HISTORIC AND DESIGN REVIEW COMMISSION

HDRC CASE NO:	2018-303
COMMON NAME:	Print Building
ADDRESS:	420 BROADWAY
LEGAL DESCRIPTION:	NCB 432 (SAN ANTONIO LIGHT), BLOCK 16 LOT 14
ZONING:	FBZ T6-1, HS, RIO-2
CITY COUNCIL DIST.:	1
LANDMARK:	San Antonio Light Building
APPLICANT:	Peter French/Gray Street Partners
OWNER:	Graystreet 420 Broadway LLC
TYPE OF WORK:	Exterior modifications to the Print Building and the construction of a connector addition to the Light Building
APPLICATION RECEIVED:	July 13, 2018
60-DAY REVIEW:	September 11, 2018

SAN ANTONIO PRINT AND CONNECTOR BUILDING

SOUTH ELEVATION

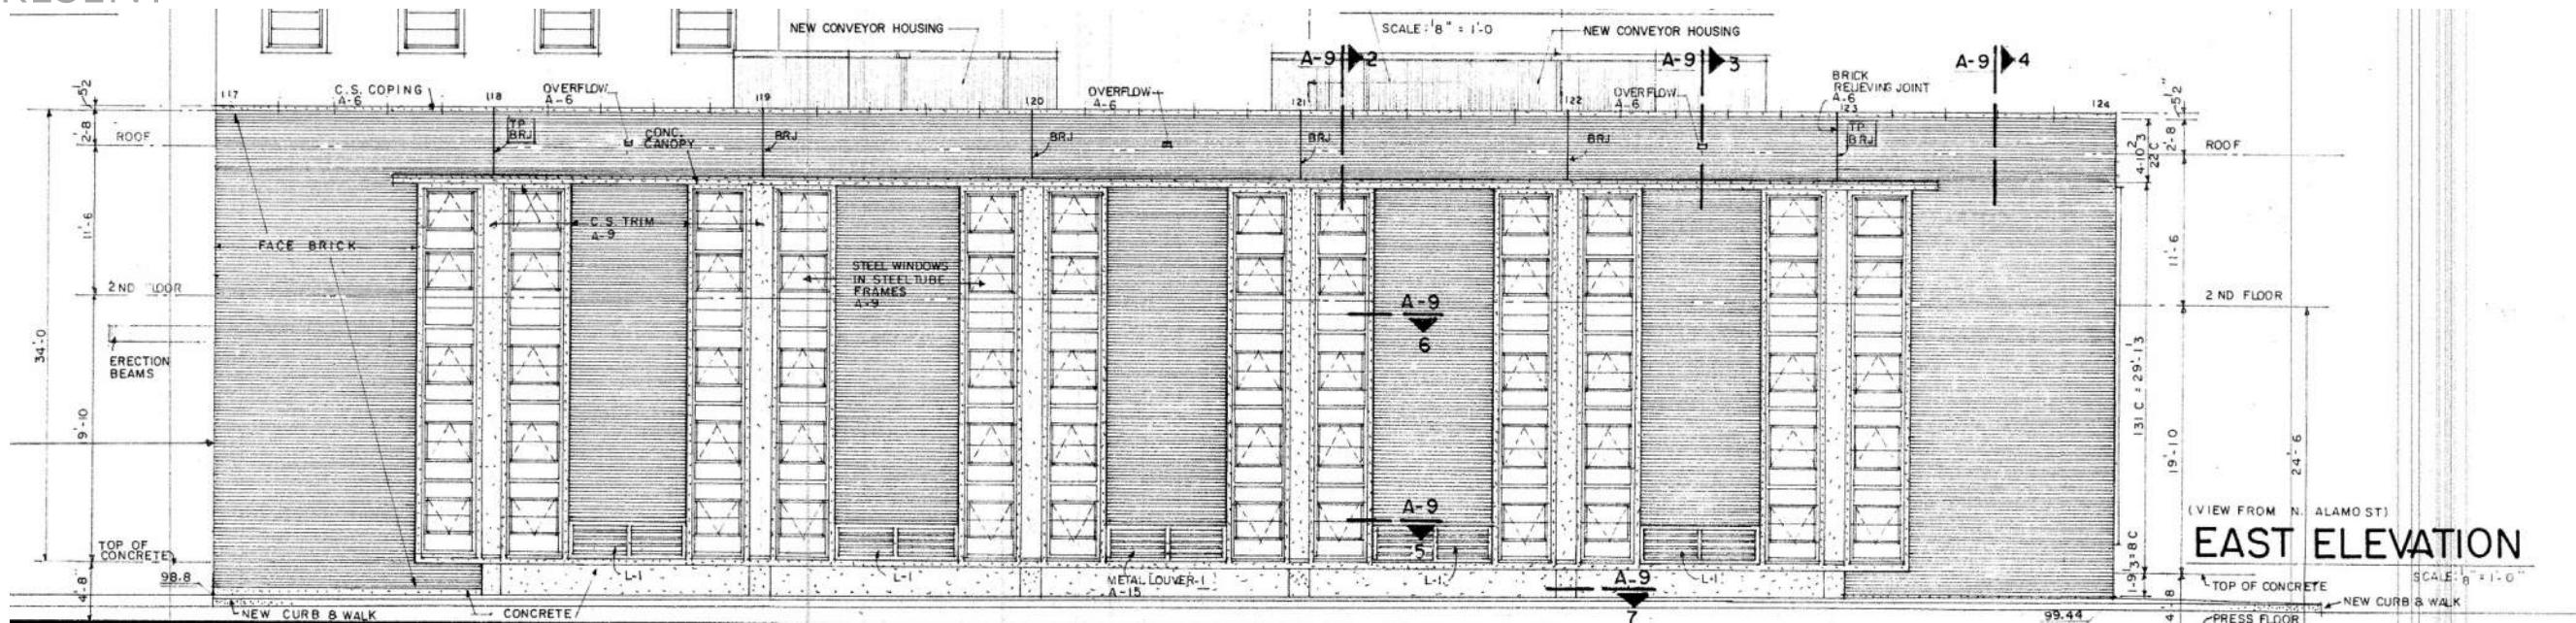
- g. PRINT BUILDING MODIFICATIONS – The Print Building currently features a tan brick façade with fenestration patterns framed by cast stone. The proposed modifications to the exterior of the structure would result in the removal of the structure's currently fenestration pattern, brick and façade arrangement. The UDC Section 35-676 notes that every reasonable effort shall be made to adapt the property in a manner which requires minimal alteration of the building, structure, object, or site and its environment. The UDC also notes that the distinguishing original qualities or character of a building, structure, object, or site and its environment, shall not be destroyed. Per the Historic Design Guidelines, Guidelines for Exterior Maintenance and Alterations 10.A., character defining features of structures zoned historic should be preserved. The removal or alteration of any historic material or distinctive architectural features shall be avoided. Staff finds that the proposed façade modifications remove the distinguishing original qualities and character of the building and are not consistent with the Historic Design Guidelines and the UDC.

- h. PRINT BUILDING MODIFICATIONS – As noted in finding f, character defining features should be preserved. The Guidelines for Exterior Maintenance and Alterations 10.B.i. notes that new features should not be introduced that alter or destroy the historic building character, such as such as adding inappropriate materials; altering the size or shape of windows, doors, bulkheads, and transom openings; or altering the façade from commercial to residential. Staff finds that the proposed modifications are inconsistent with the Guidelines.

1. Staff does not recommend final approval of item #1, exterior modifications to the Print Building based on findings g and h. Staff recommends that the applicant adhere to the UDC and preserve original materials and design elements of the existing building or propose a design that is more in keeping with the construction period and design aesthetic of the Print building.

JF: BELIEVES STRUCTURE HAS HISTORIC VALUE. WOULD LIKE TO SEE NORTH AND EAST FAÇADES (SPRISTS) PRESERVED. BRICK COLOR SHOULD BE CLOSER TO MATCH EXISTING. RESPECTING DIFFERENCE IN ELEVATIONS IS IMPORTANT. DOES NOT SEE ISSUE WITH ADDITIONS ON TOP - APPROPRIATE APPROACH.

JS: NOT IN AGREEMENT ON BRICK COLOR? JF: SAN ANTONIO HAS TAN BRICK FOR VERNACULAR REASONS - CURRENT COLOR IS TOO DARK (EG+AL AGREE).

COMMENTS/CONCERNS: JS: MOCK UP CREATED OF BRICK - OWNER DOES
NOT WANT TO ~~INCLUDE~~ INCLUDE TAN BRICK. MG: NO CONCERN OVER
CONNECTOR ADDITION - DESIGN APPROPRIATE. ~~MG~~ EXISTING ELEVATIONS
HOLD SIGNIFICANCE. EG: NEW FAÇADES SHOULD BE SYMPATHETIC TO
PREVIOUS DESIGNS. THE RED BRICK IS TOO MUCH OF A DEPARTURE FROM
THE ORIGINAL BRICK; BRICK SHOULD RELATE TO EXISTING IN COLOR.

JS: WILL DETERMINE NEW BRICK COLOR AND WILL RETURN WITH UPDATED
FENESTRATION. MG: PROVIDE WALL DETAIL NOTING INABILITY TO WATERPROOF
PRINT BUILDING'S FAÇADE

NORTH ELEVATION

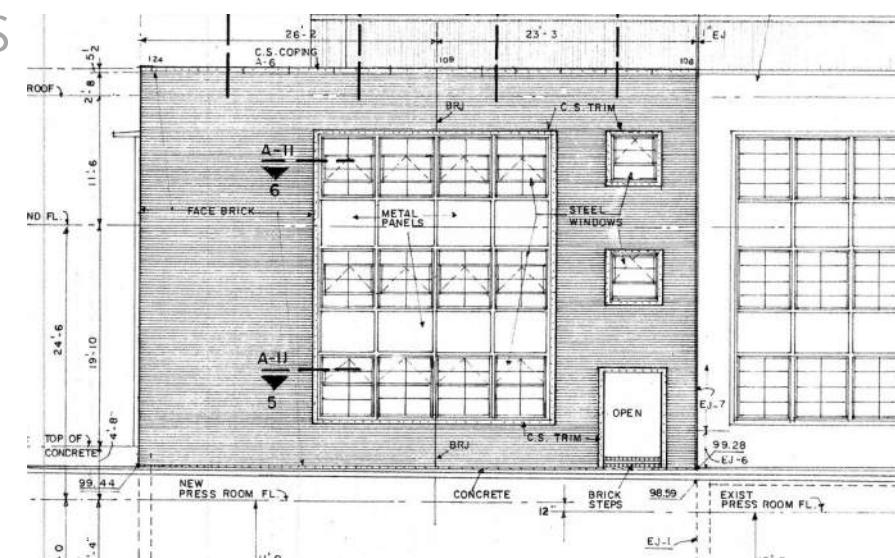
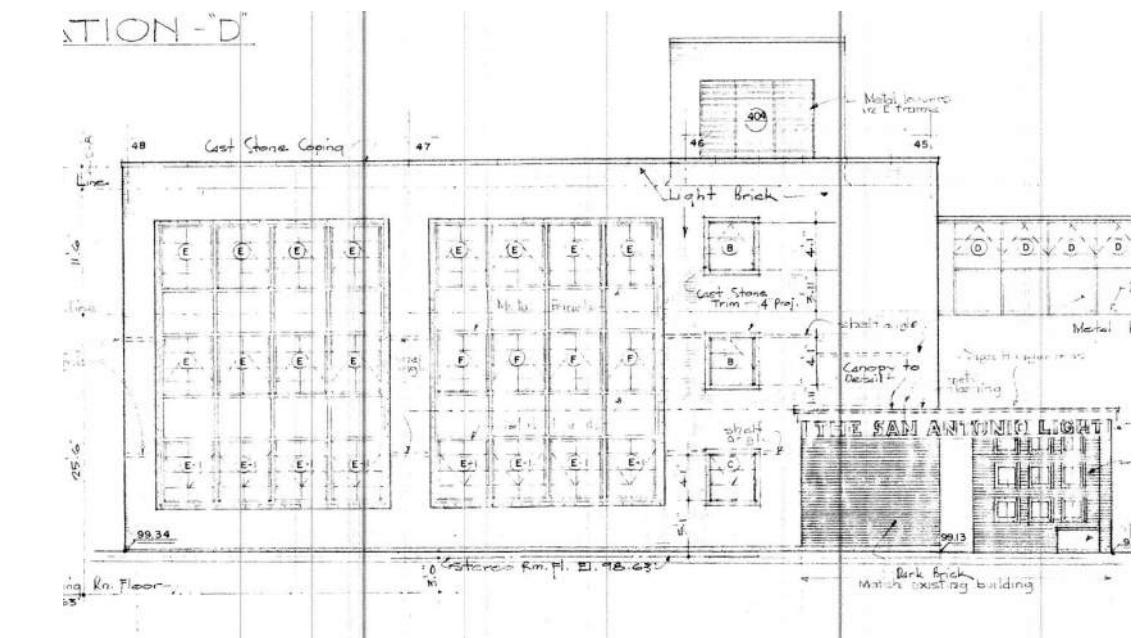
Staff finds the existing façade of the Print Building to hold architectural integrity as an example of the Mid-Century Modern style. Should the Historic and Design Review Commission find the proposed modifications to be inappropriate, staff recommends the original façade be reconstructed as it existed prior to demolition. Additional façade openings originally existed on the N Alamo façade and could be restored to allow for additional fenestration.
